No matter *HOW* one photographs it, Toomerfs' parking edifice would:

RE: Outstanding Issues with the Toomerfs, LLC's Site Plan and Conditional Use Permit Applications

EXHIBIT B: Chesley Drive, Existing

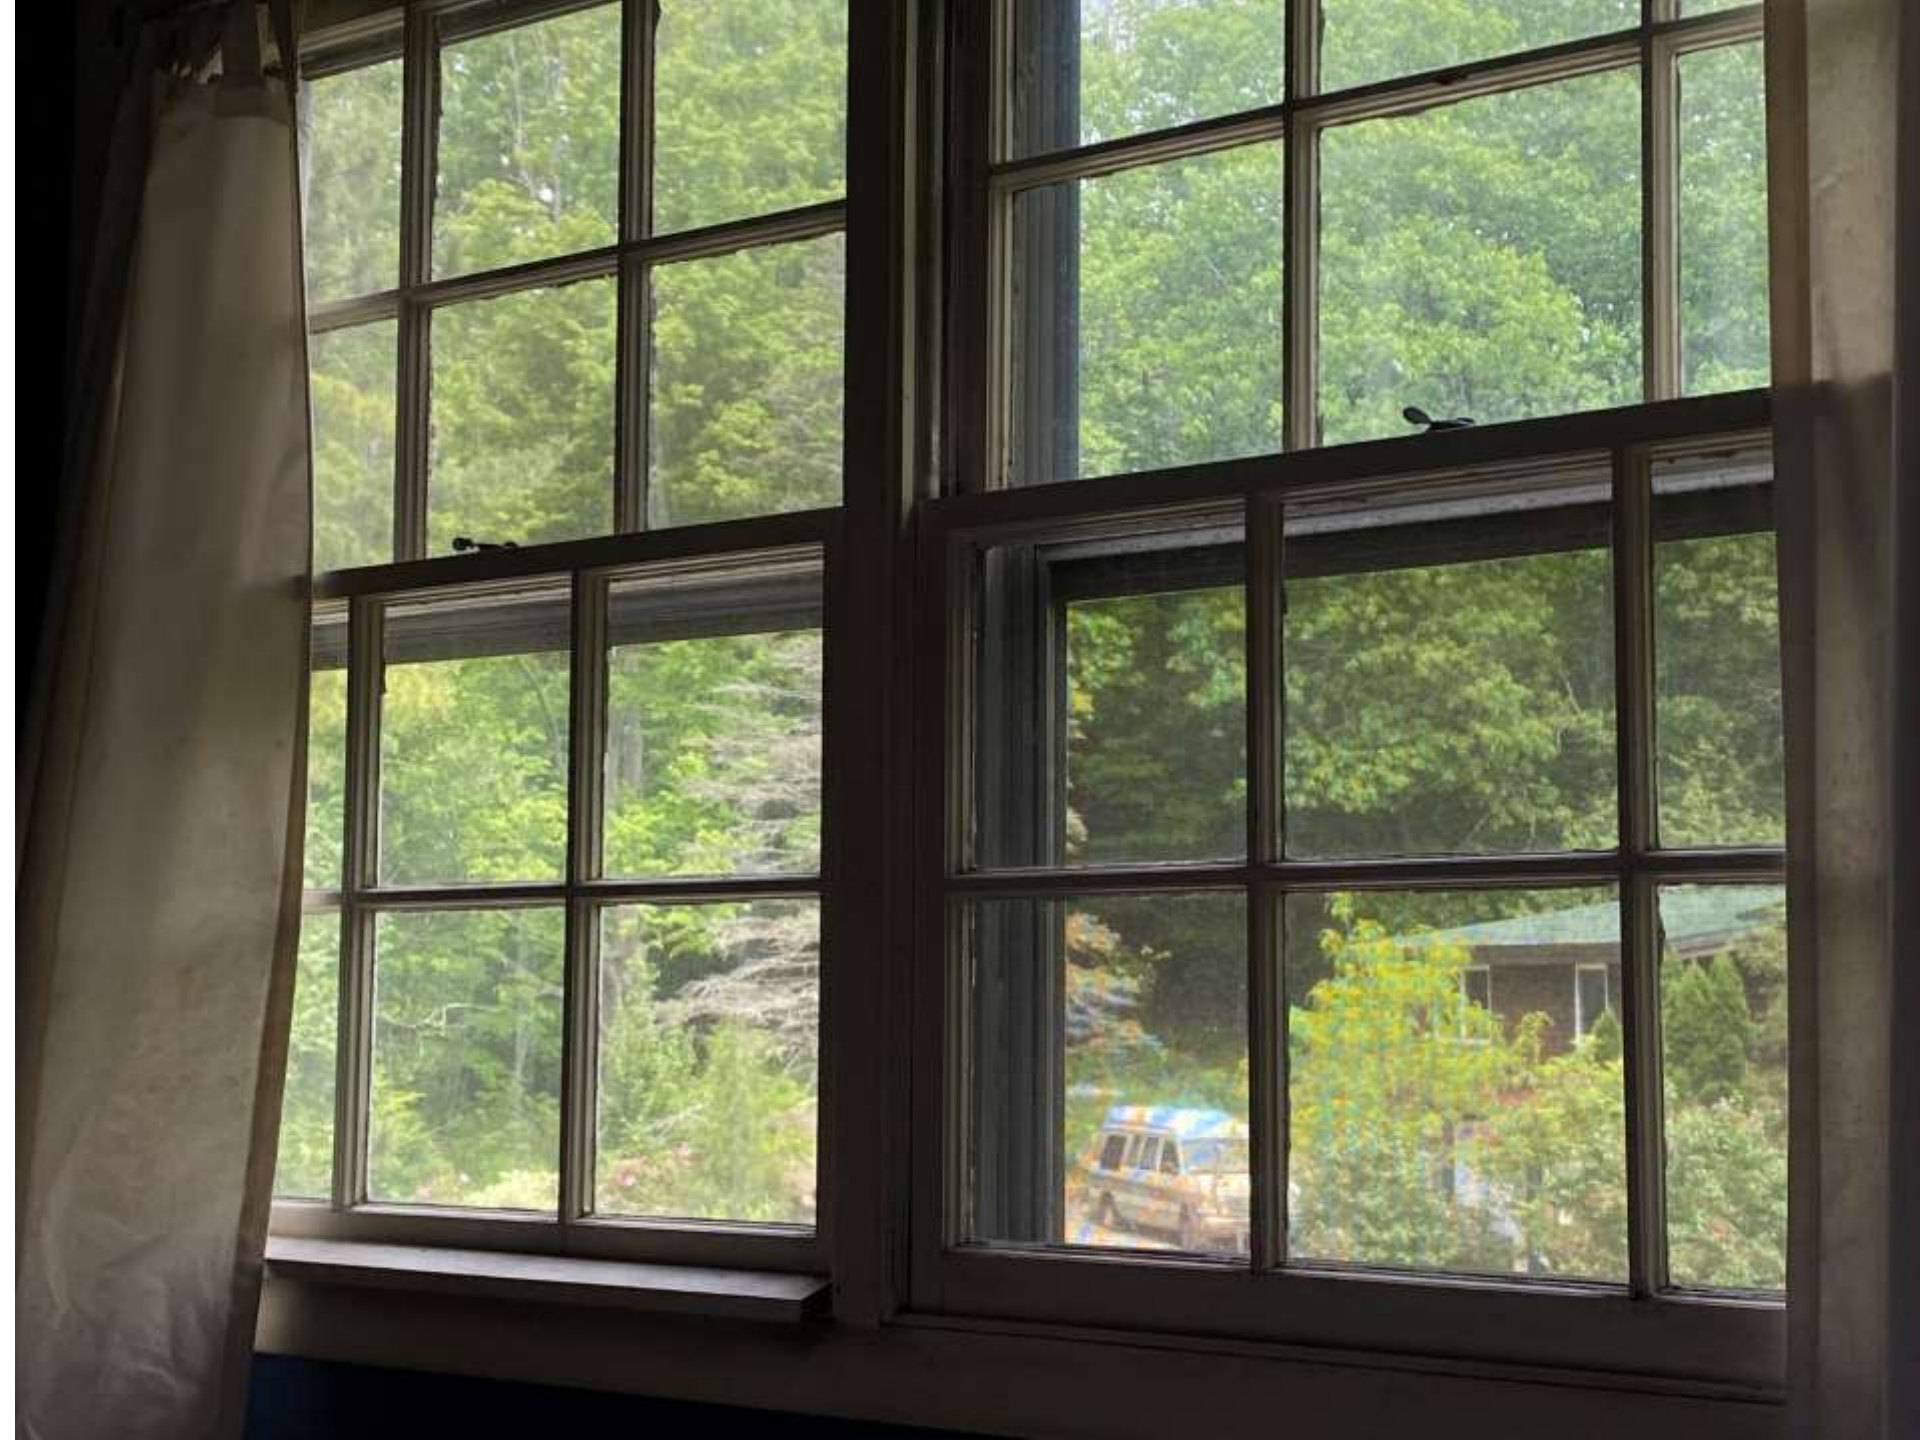
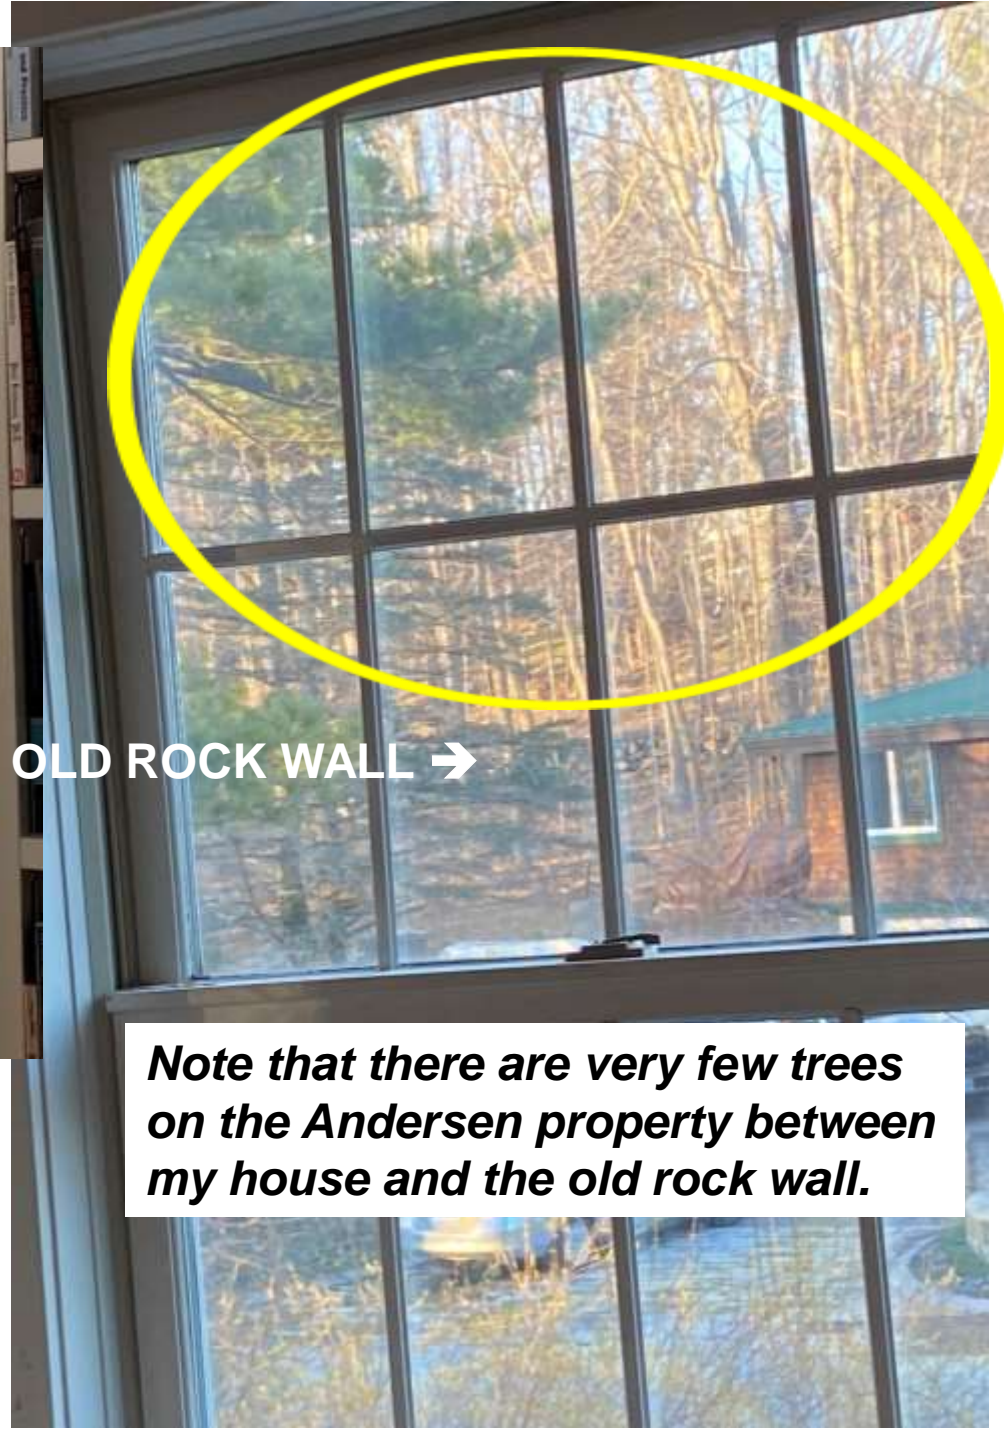
Toomerfs implausibly show the “existing” and “proposed” views from Chesley Drive as essentially the same

Yet, there would be a gaping hole in the viewshed – particularly in the spring, summer, and fall – if the Toomerfs’ parking lot proposal were to be built.

Distorted Toomerfs'
Chesley Dr "after"
rendering

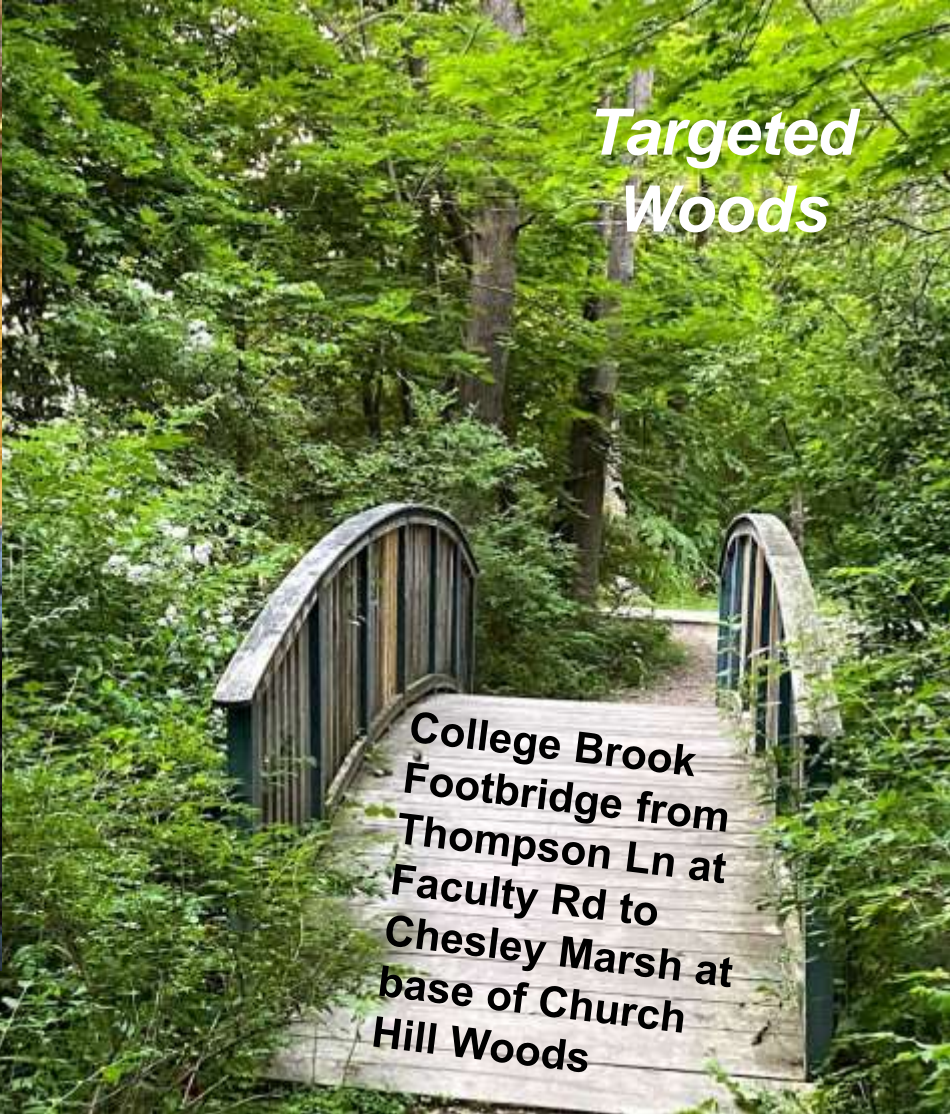
Anyone doubting how distorted the Toomerfs' Chesley Drive "after" renderings are (*with the targeted Church Hill Woods still in place*), is welcome to stand in my driveway or knock on my door to see the imposing Church Hill Woods views (year-round!) from my north-facing windows on all levels.

– with targeted
Church Hill Woods
still in place.

Toomerfs' [3-D Rendering of Plan 12-15-21](#)

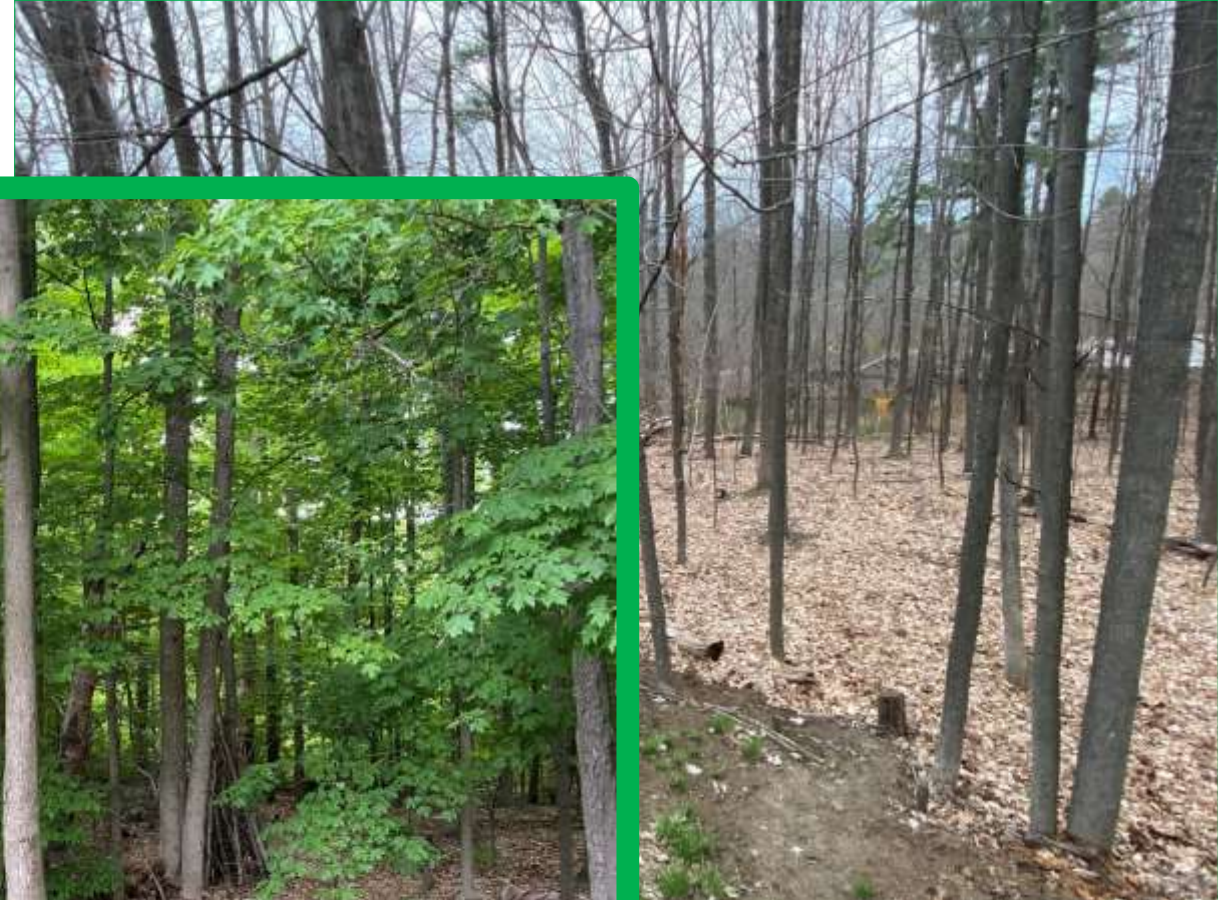
Can anyone believe that Toomerfs' Parking Edifice would look like this from Mill Plaza?
after taking out trees, raising the grade (with paving) up to 20ft, adding vehicles, & 14-ft lighting poles

EXHIBIT F: Urso Residence, Proposed
Prepared by: Tangram 3DS Date issued: 2022-06-02

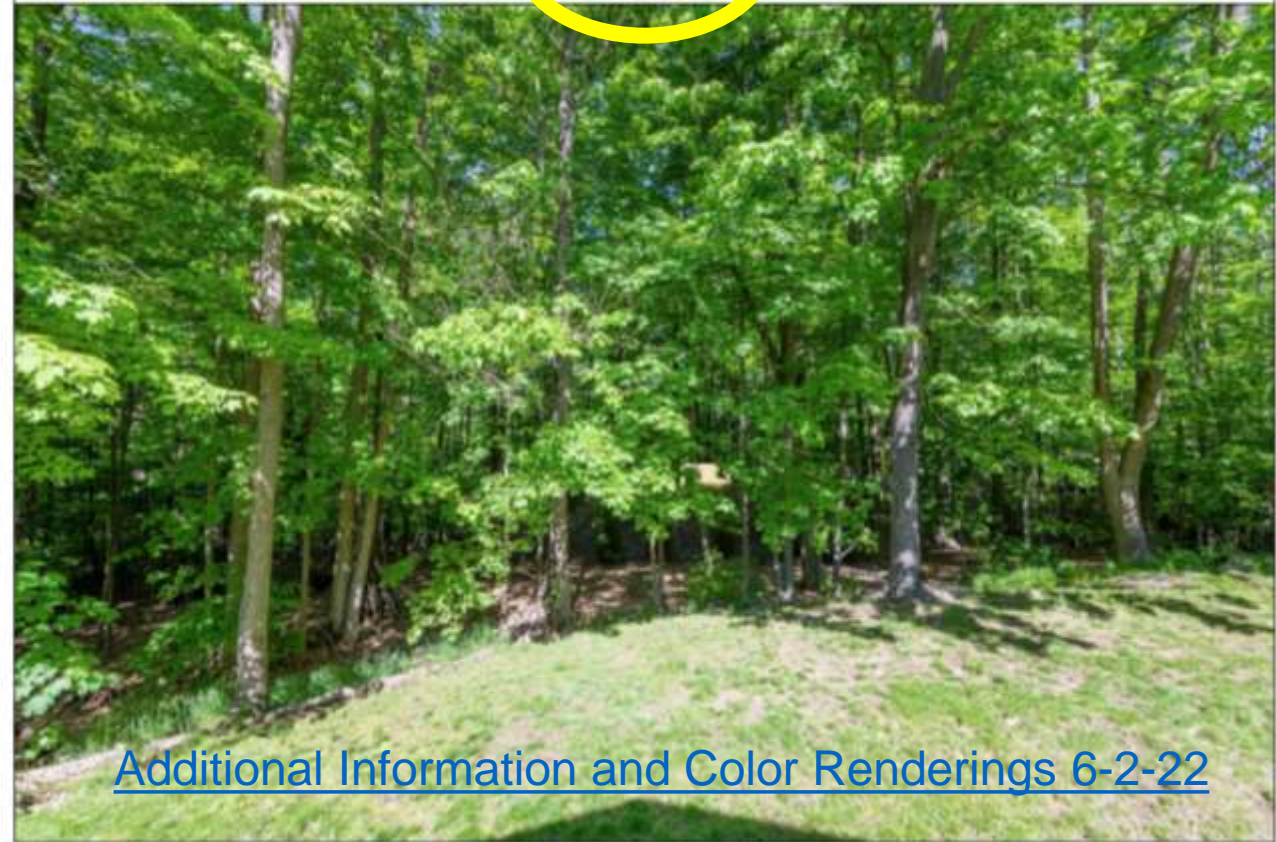
Since Mill Plaza is visible in the distance from the Urso home *in all seasons*, how could a massive parking fortress (as in prior slide) essentially disappear, per June 2022 “Proposed” image below?

Exhibit D: Chesley Drive, Proposed moonscape, 2022-06-02

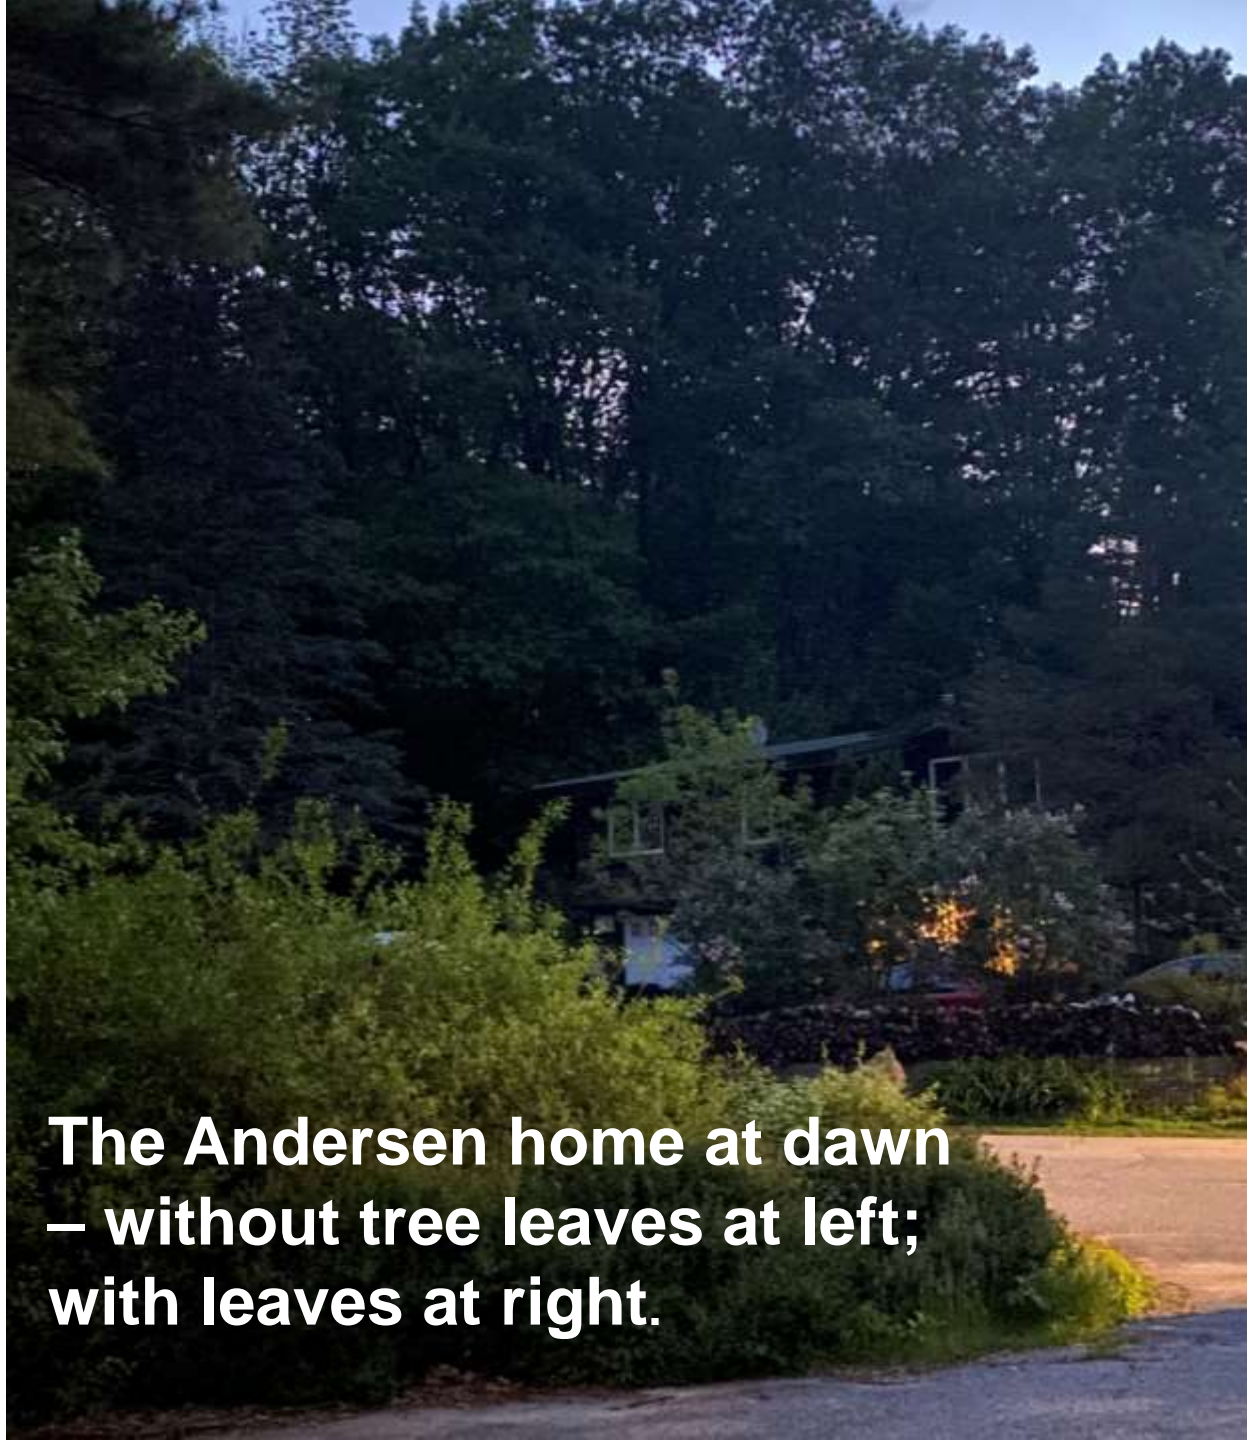
**Why have we waited for months for accurate renderings
from abutting Andersen home at 8 Chesley Dr?**

When we will finally see the **close-up details** of the edifice that is being proposed for a short distance upland of this wall (visible from the Andersen home's windows)?

We need to see accurate renderings! *With the targeted trees gone.*
